P98-014 - McDonald's Restaurant @ 2517 Del Paso Blvd.

- REQUEST: A. Environmental Determination: **Categorical Exemption (Section 15302)**
- B. **Special Permit** to operate a drive-up service facility for a 3,693 ± sq. ft., 96 seat restaurant on a 0.75 vacant developed acres in the General Commercial (C-2) zone.
- C. **Variance** to allow one additional attached sign in the General Commercial (C-2) zone.

LOCATION: 2517 Del Paso Blvd. between Plaza Avenue on the south and Lampasas Avenue on the north.
APN: 265-0292-041
North Sacramento
North Sacramento, Grant Joint Union School Districts
Council District: 2

DEL PASO BOULEVARD
(NEW)
SCALE: 1" = 40'-0"

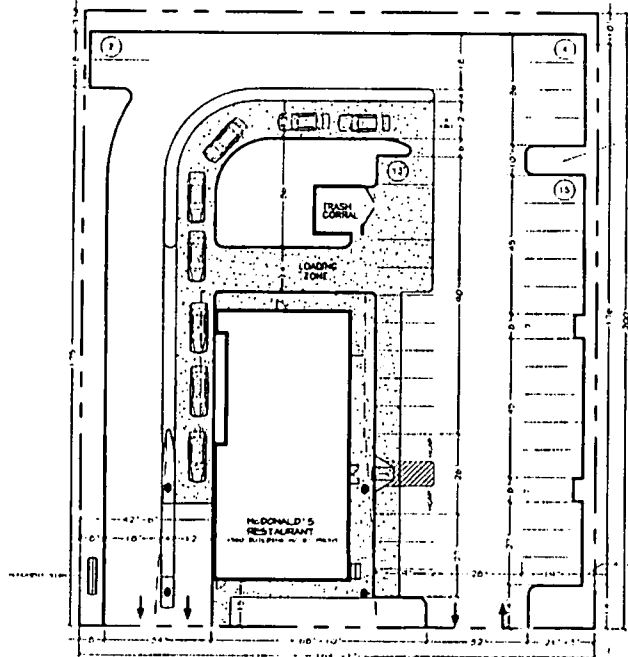
The proposed project would need to meet the fifty percent shading requirement by providing more shade trees. Staff also recommends that planter boxes be provided along the western property line which is adjacent to an unimproved alley.

- a. The throat distance for the northerly driveway should be 40 feet measured from the street right of way. This will decrease the parking stalls by 6 assuming one of the handicap stalls can be moved to the north parking stall tier. An alternative to not decreasing the number of stalls may be to decrease the width of the standard car stalls from 9 feet to 8 feet and the width of the compact car stalls from 8 feet to 7.5 feet.
- b. The southerly driveway should have a one lane exit to prevent left-right turn conflicts. This may be able to be accomplished by merging the drive-thru lane with the parking exit lane prior to the street right of way.
- c. The drive-thru point as shown on the 3/31/98 plan should be moved downstream one car to provide four car stacking upstream of the order point.
- d. A traffic study will not be required.

1. The applicant shall provide a wrought iron fence along the southern lot line which would be adjacent to the thrift store parking area.
2. The applicant shall provide more shade trees in order to meet the fifty percent shading requirement,

3. The applicant shall place planter boxes along the western property line adjacent to the unimproved alley.
4. The applicant shall work with the Design Review staff to design appropriately sized signs which are discreet to the project.

Signage Plan: Side Elevations
Exhibit 1F

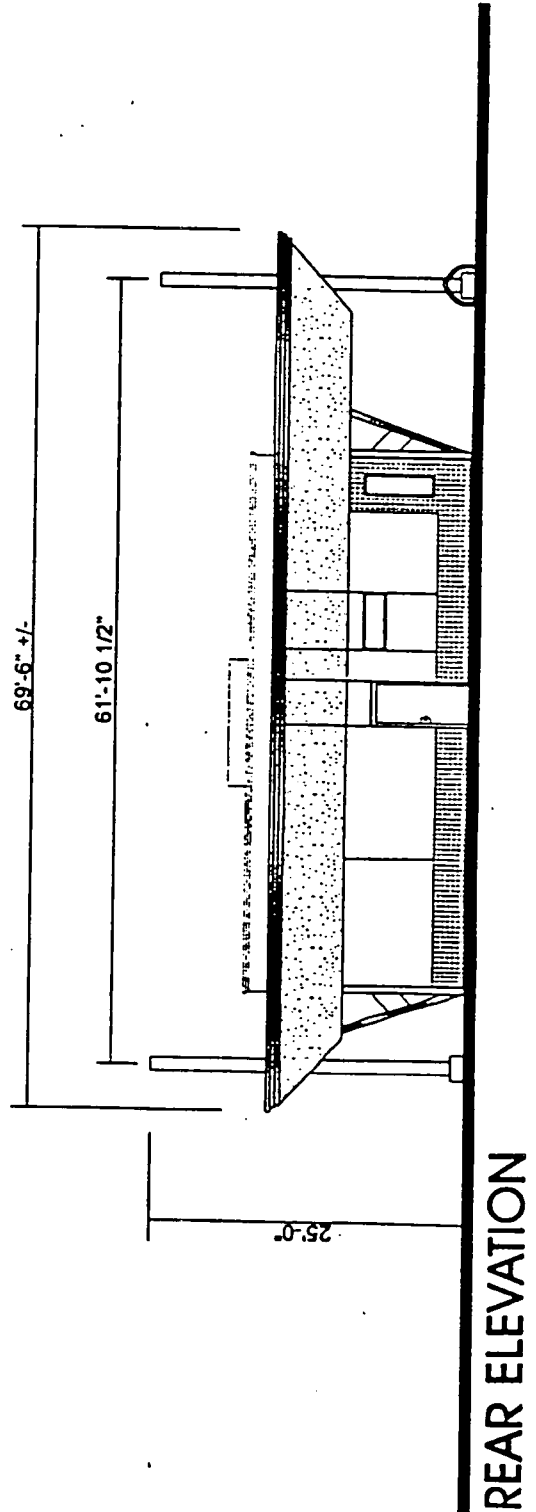
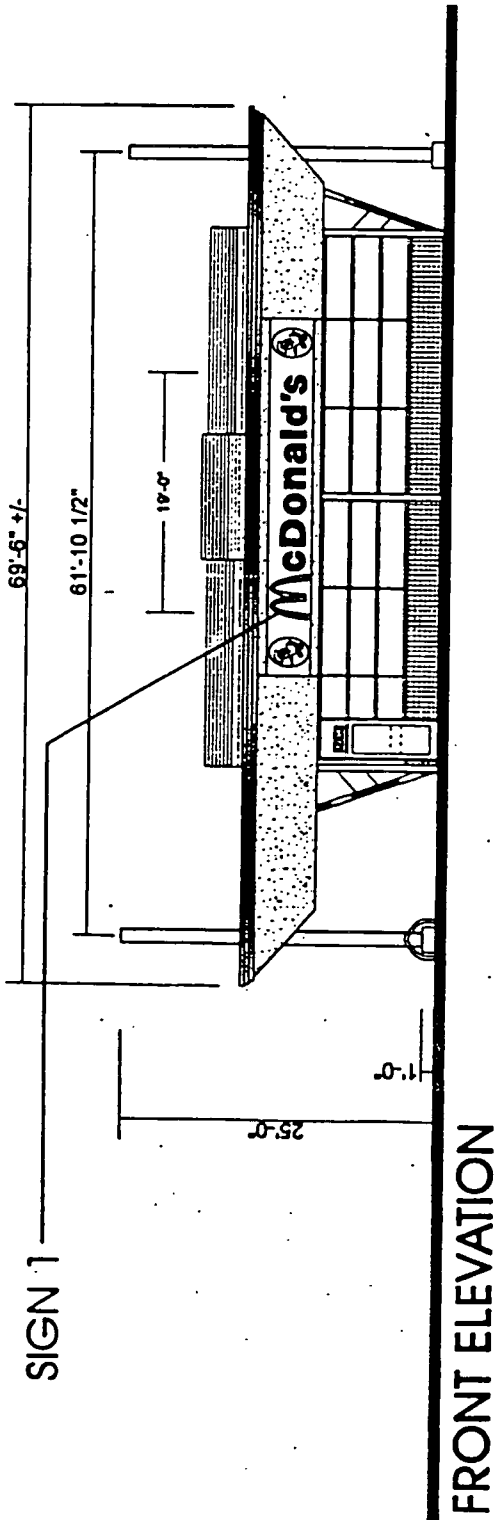
tiles on the north and south sides of the building be removed. (The Design Review report erroneously identified this as the east and west sides). The signage plan that was submitted to the Planning staff did not have the tiled "M" on each of the sides, nor does it have the "M" logo with "McDonald's" written in smaller letters in the Logo area in the window area as is shown on the plan elevations. Staff will support the signs as shown on the signage plan with recommended changes (see "Signage Table" below)- not the signage as shown on the plan elevations.

<p>Letter "M" logo with the word "McDonald's" at the bottom of the letter as shown on submitted Plan elevations-no on signage plan.</p>	<p>Window area on side elevations near the front</p>	<p>Eliminate</p>
---	--	------------------

- a. The monument sign shall not exceed six feet in height.
 - b. The "McDonald's" sign proposed for the street facade shall be reduced by one-third.
 - c. The "M" proposed on the tile area shall be removed.

Exhibit 1E
Signage Plan: Front and Rear Elevations

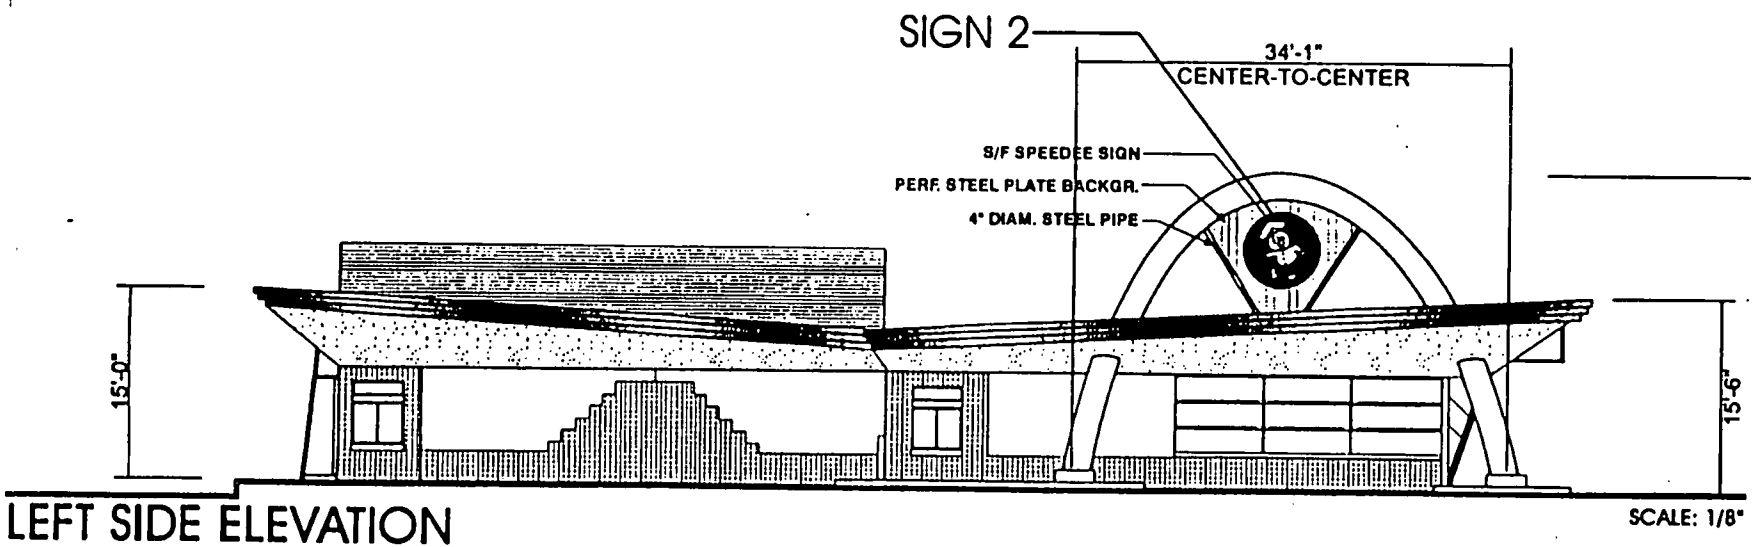
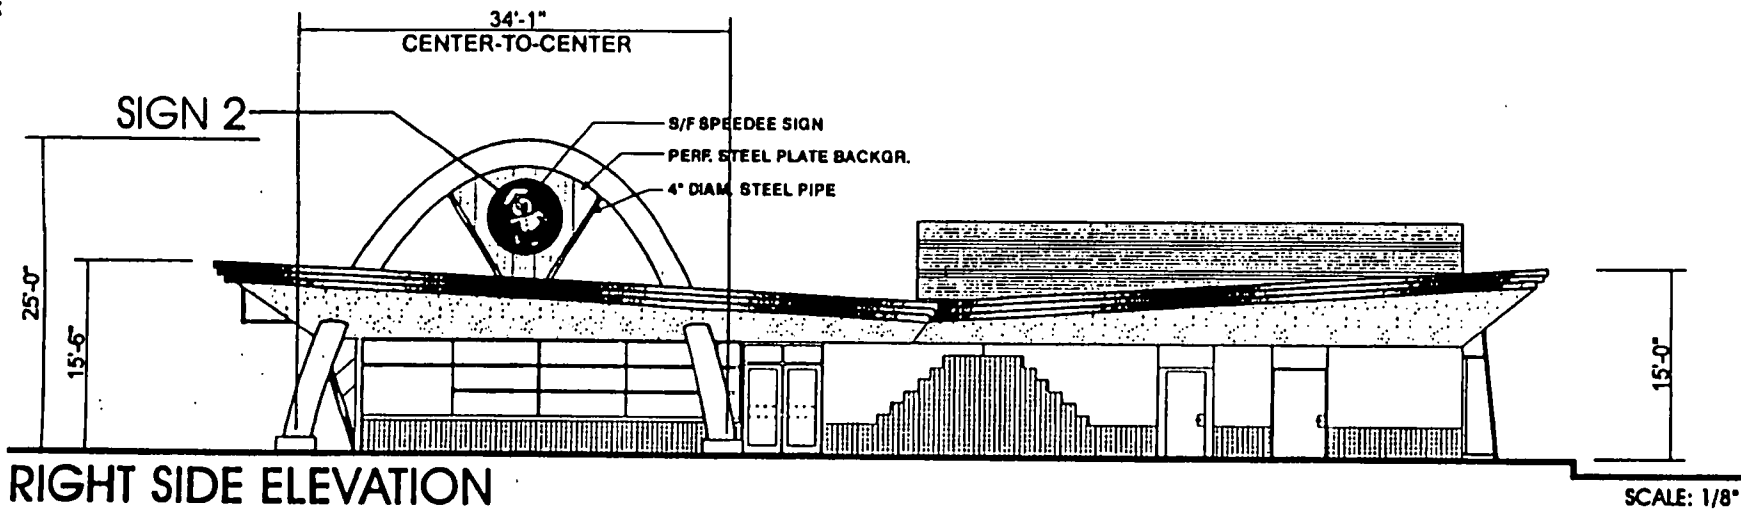
"The "McDonald's" sign proposed on the street facade appears too large and should be reduced in size. Because of the two "Speedee" signs, this sign is considered by the City Sign Ordinance to be an additional sign, and a variance is required for approval. Staff supports the variance if the sign is reduced in size, and if other signage is deleted. Specifically, staff feels that the "M" proposed on the tile area at the east and west elevations should be removed. The McDonald's small signs proposed at the window area on the east and west sides should be sufficient.

Planning staff supports the conclusions of the Design Review staff and recommends that the "McDonald's" sign on the front facade be reduced in size by one-third. Staff also recommends that the two "M's" on the

Sign Identification	Location	Recommendation
Sign #1(as identified on the signage plan) McDonald's with Speedee logos on each side	Front Elevation	Reduce size by one-third
Sign # 2 Speedee Figure	Under the arch above the roof on right and left sides	Size is okay
Monument Sign	South front corner next to Del Paso Blvd.	Reduce the height from 8' 6" to six feet. Eliminate the word "McDonald's" on bottom of sign to achieve the height reduction to six feet.
Letter "M" logo on tiles on as shown on submitted Plan elevation- not on signage plan	Side Elevations	Eliminate

Signage Plan: Monument Sign

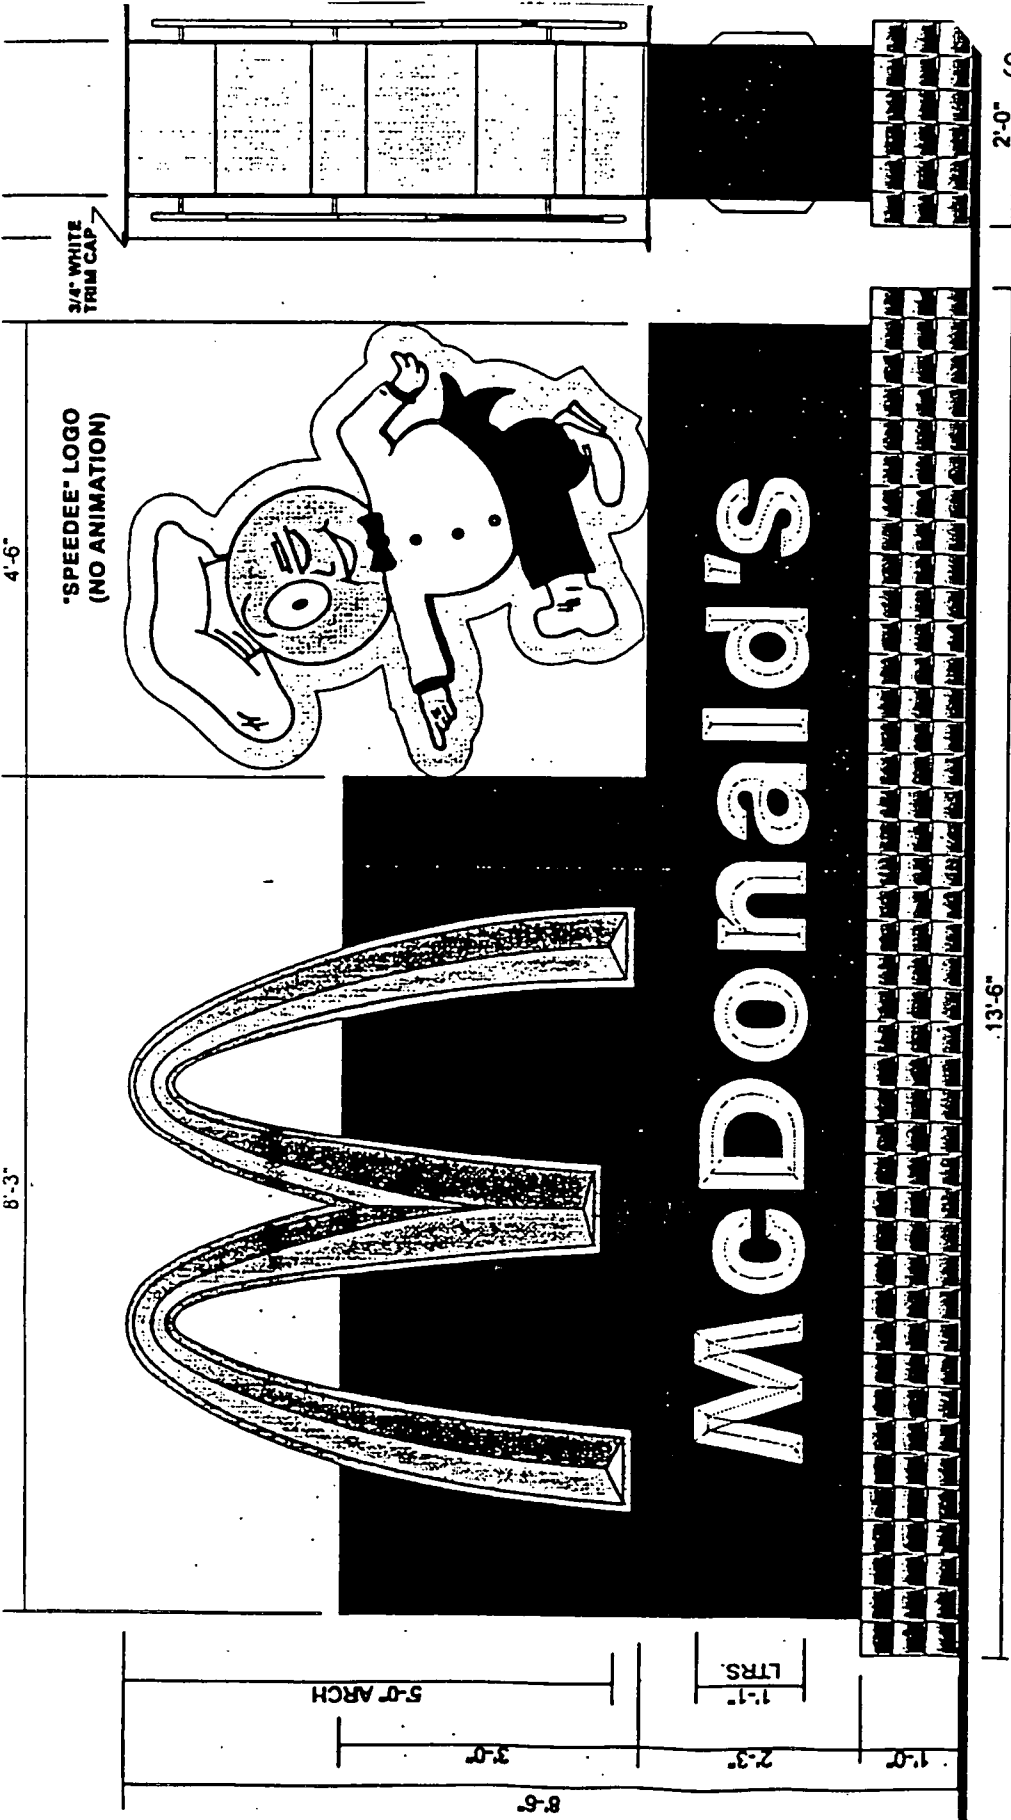
The monument sign proposed also includes the "Speedee" logo. Staff supports the monument sign design, but feels that the overall height should not exceed 6'-0". This can be achieved by removing the word "McDonald's" from the sign, and simply leaving the "Speedee" logo, with the McDonald's "M". Final signage will be reviewed by staff to provide adequate, yet discreet signage that does not detract from the design of the building."
